# FMB122 Product Change Notifications

**Product change notifications (PCN)** is the way of informing customers of upcoming changes related to Teltonika products. This includes outward appearance adjustments, hardware improvements, firmware changes, changes to package contents, etc. This page stores information regarding changes to the FMB122 tracking device. Below you will find a list of both upcoming and already implemented changes sorted from newest to oldest (top to bottom).

## 2021.01.01: Top Laser Printing Changes

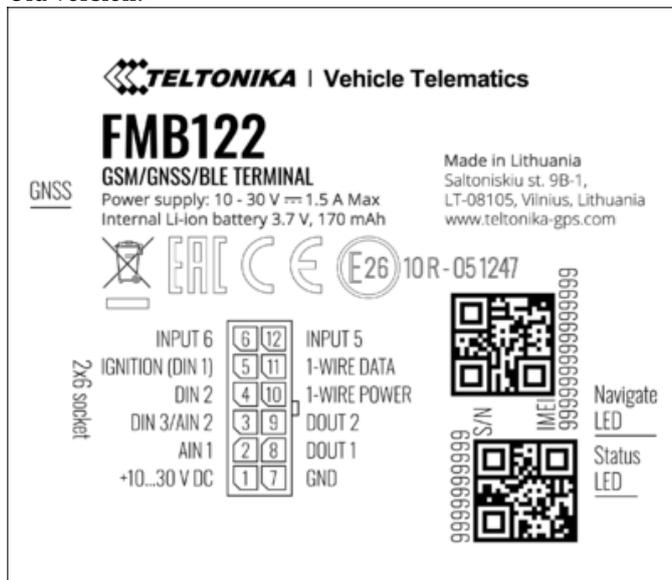
We would like to inform you, that laser printing of the FMB122 device was updated in the factory in January 2021.

| Change type | External/visual<br>Top laser printing design changed<br>Old version: |

1. Updated Emark certificate number.
2. Added UKCA label.
3. Updated Teltonika brand to Teltonika Telematics.
